California IOUs & NRDC Response to CEC Standards Proposal - Computers

Response to CEC Standards Proposal for
Computers

Docket #14-AAER-2A

May 29, 2015

Figure 3.1: Average Display Allowances Across QPL for May 2014 - April 2015 Models - Standard Display

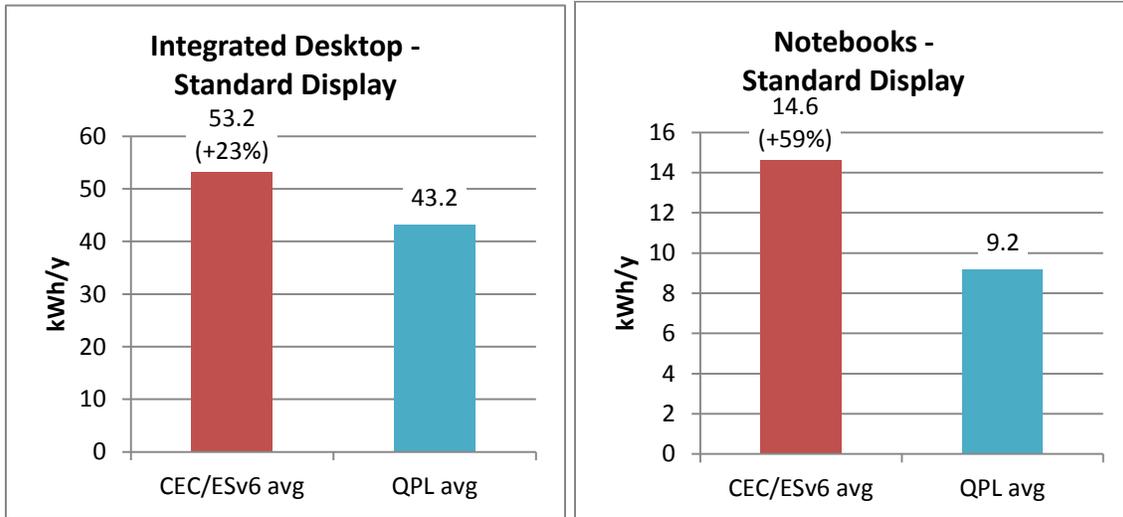
Figure 3.1 shows that CEC proposed adders, based on ENERGY STAR v6, are on average 23% higher than the difference between short and long idle in the QPL for integrated desktops, and 59% higher for notebooks.

These differences have a huge impact on the effectiveness of the standards, because display allowances are of the same order of magnitude as the base allowance for the system: 53 vs 50 kWh for integrated desktops, 15 vs. 30 for notebooks. In a TEC approach where excessive adders can give inefficient systems a free pass to comply, it is critical to pay attention to adders like displays so that the overall cost-effective and feasible energy savings are optimized.

Figure 3.2: Comparison of Average Display Adder Proposal vs. CEC/ENERGY STAR v6.1 and QPL (May 14–April 15) – Standard Display

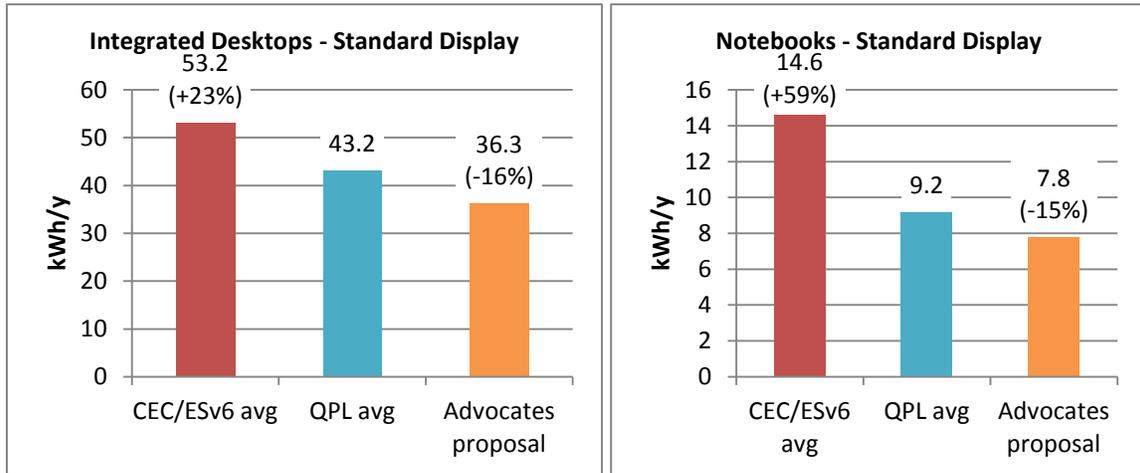
Figure 3.2 shows how these proposed levels compare with ENERGY STAR v6.1 and with the QPL on average.

Our proposed levels yield “pass rates” of 21% of the QPL for integrated desktops (54% for enhanced performance displays, or EPDs), and 29% for notebooks (44% for EPDs) as shown in Table 3.1. The substantial number of units achieving these levels demonstrates their technical feasibility and broad availability in the market today. Note that these are not real pass-rates, we’re using conservative estimates of display power.

Figure 3.7: IOU, NRDC and CLASP measurements of dGfx, 2011 - 2015

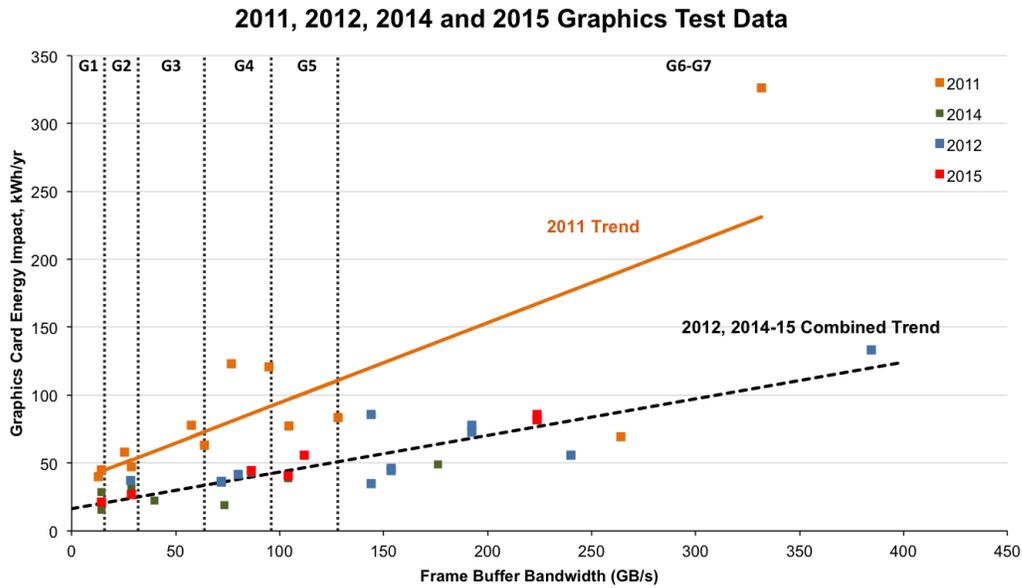
GPU manufacturers have dramatically improved the efficiency of their products in the past half-decade. Until 2011, many discrete GPU products consumed as much energy as a desktop computer itself. Today, thanks to process improvements and enhanced power management, even the highest specification cards have power demands less than 10 W (DC) during idle modes (Tom's Hardware, 2015). The CASE team, along with CLASP and NRDC, has developed a dataset of discrete GPU power measurements since 2011 (35 dGfx in all) and have observed a step decrease in energy consumption. Figure 3.7 illustrates the incremental TEC impacts of a broad sampling of dGfx, displayed as a function of frame buffer bandwidth (FBB) in GB/s (a proxy for overall card performance and graphics throughput). The chart also displays the FBB limits of each ECMA performance category. In 2011, a typical G4 dGfx contributed an additional 102 kWh/yr to a desktop's TEC, but now only adds 35 kWh/yr, a 66% decline.

Figure 3.9: VirtuWatt motherboard integration. Discrete graphics card (green) is power managed by control circuit (purple). Source: LucidLogix, 2015

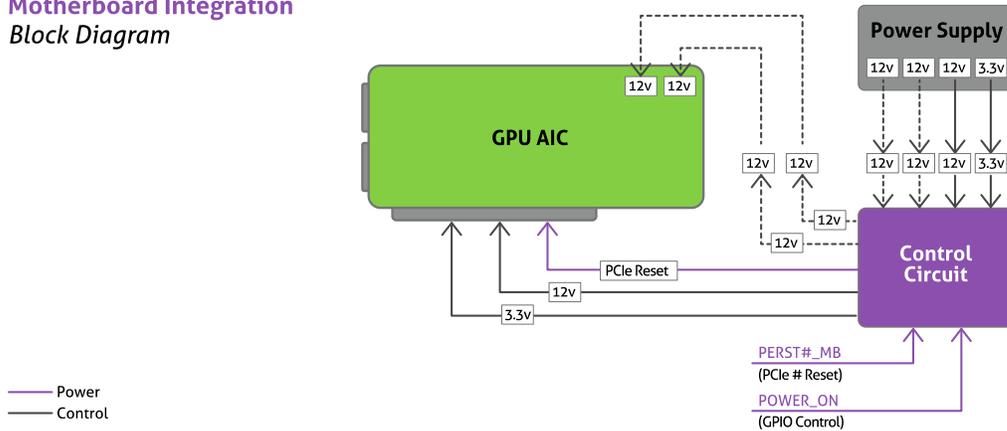
manufacturer LucidLogix to incorporate Lucid’s “VirtuWatt” graphics switching technology into certain desktop products. Fujitsu’s implementation is branded as “Virtu Green” and is available in select CELSIUS workstations and ESPRIMO desktops.⁴ Asus has more recently incorporated VirtuWatt on gaming PCs to enable an “Eco Energy Mode” with low idle power.⁵ VirtuWatt is a combination software/hardware solution. Software is used to “virtualize” GPUs, route requests to the appropriate graphics component, and channel output signals to a single port (usually the motherboard’s display port). A power microcontroller is incorporated into the motherboard or the card itself to power manage the discrete GPU (see Figure 3.9 below).

Figure 3.10: Incremental TEC consumed by desktop computers with additional installed memory. Source: ENERGY STAR qualifying products list, 2015

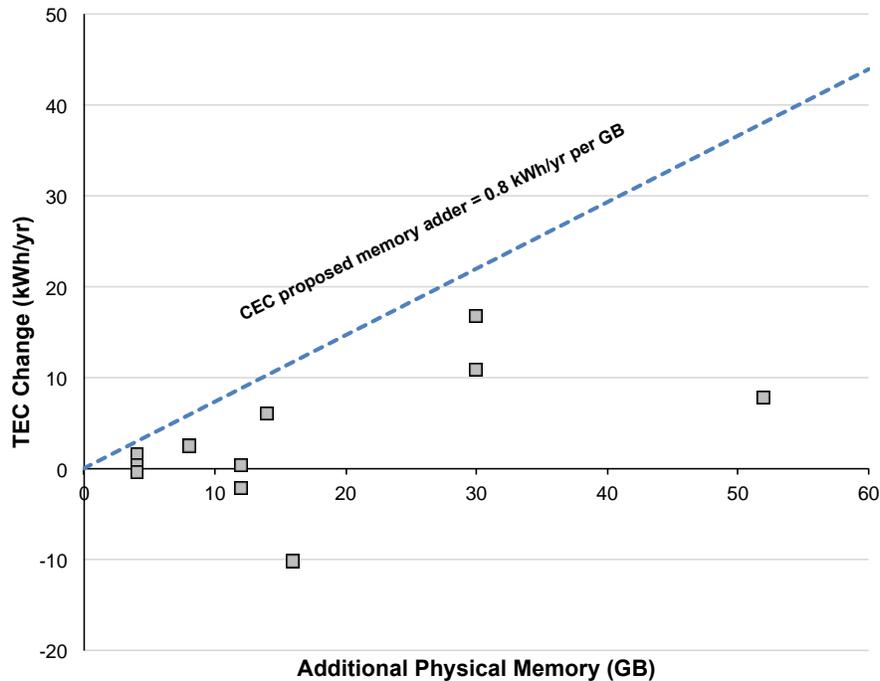
Even compared to today's designs using DDR3 memory, the staff proposal is too conservative for establishing an energy efficiency standard. The CASE Team has identified computer models on the ENERGY STAR QPL with identical model numbers and equivalent (or occasionally higher performance) processors, but differing amounts of physical memory, allowing for a comparison of real memory TEC impacts. As Figure 3.10 shows, the total amount of installed physical memory is a relatively poor indicator of energy use and, therefore, should not be used as a basis for granting functional allowances.⁷ Furthermore, the proposed 0.8 kWh/yr per GB value is overly conservative and can grant over 50 kWh/yr of additional TEC to high-end systems (twice that amount as 16 GB DIMMs become available, enabling 128 GB memory installs in high-performance systems).

Recent testing conducted by Aggios suggests that the incremental power consumed by memory tends to scale more closely with the number of populated dual inline memory module (DIMM) slots on the motherboard than with overall capacity. Aggios’ testing also shows that memory typically consumes about 1.3 to 2.2 kWh/yr per installed DIMM, based on today’s DDR3 technology.

The CASE Team proposes an alternative memory adder informed by Aggios’ testing and our current understanding of memory energy usage. Our proposal grants no adder for the first DIMM installed in the system (its energy use is covered by the base TEC allowance), but provides a 2 kWh/yr adder for each additional installed DIMM. Mathematically expressed, this is

$$TEC_{\text{memory}} = 2 * (n_{\text{DIMM}} - 1) \text{ kWh/yr,}$$

Figure 4.1: Percent increase in TEC under real-world test conditions compared to ENERGY STAR measured TEC

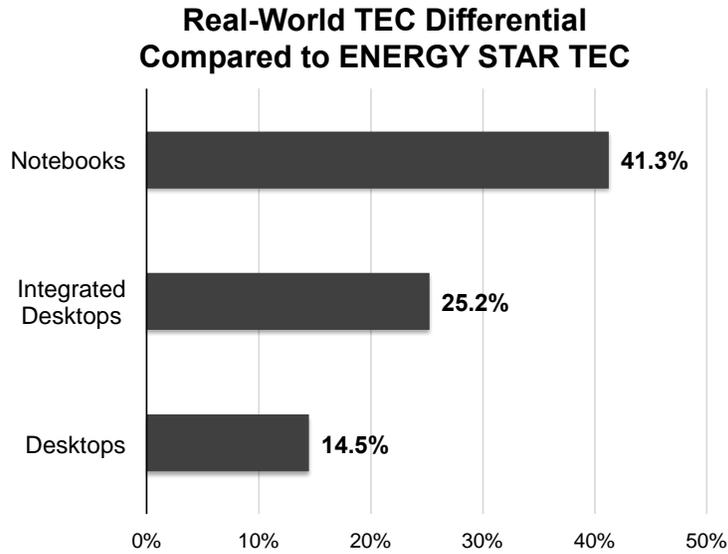
The CASE Team proposes that CEC utilize our latest published $TEC_{\text{adjustment}}$ factors (Figure 4.1) with a 50% weighting when applying them to energy savings and cost effectiveness estimates.

The CASE Team has been examining the impacts of real-world usage on computer energy use since mid-2014 and have generally found that ENERGY STAR-reported TEC values need to be adjusted to determine actual energy use in the field. We provided initial results of this research as part of our October 2014 CASE report addendum (CA IOUs 2014). Our most recent analysis shows that computers can consume anywhere from 15 to 40% more energy under real-world conditions compared to ENERGY STAR-reported TEC (see Figure 4.1), not including the duty cycle adjustment discussed above. As discussed in earlier comments, such adjustments for field usage could increase energy savings for the same cost, and therefore increase cost effectiveness for the proposed standard. We recommended CEC use a TEC adjustment factor in its analyses. Specifically, we recommend adopting the adjustments presented in Figure 4.1 with a 50% weighting. Accordingly, this would mean an adjustment of 7.25% for desktops, 12.5% for integrated desktops, and 20.5% for notebooks.

Figure 5.1: Efficiency Profiles of 80-PLUS GOLD Power Supplies

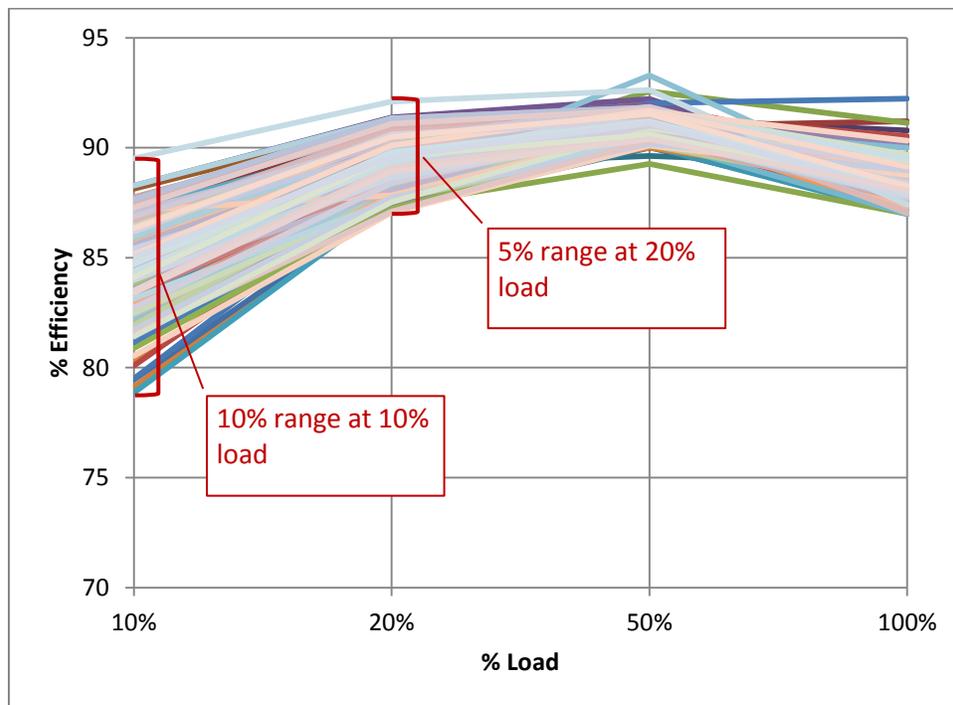
In fact, the 80-PLUS program has been testing all power supplies at the 10 percent load point since January 2012, despite this load point not being part of the 80-PLUS standard. The test data is available on the 80-PLUS website¹². An analysis of this data on Figure 5.1 shows that the range of efficiencies is twice as large at 10 percent than at 20 percent load, confirming that the 10 percent load range is not consistently optimized.

We recommend the CEC adopts efficiency requirements of 84 percent for 80-PLUS Gold, in alignment with ENERGY STAR v6.1's power supply efficiency incentive allowance.
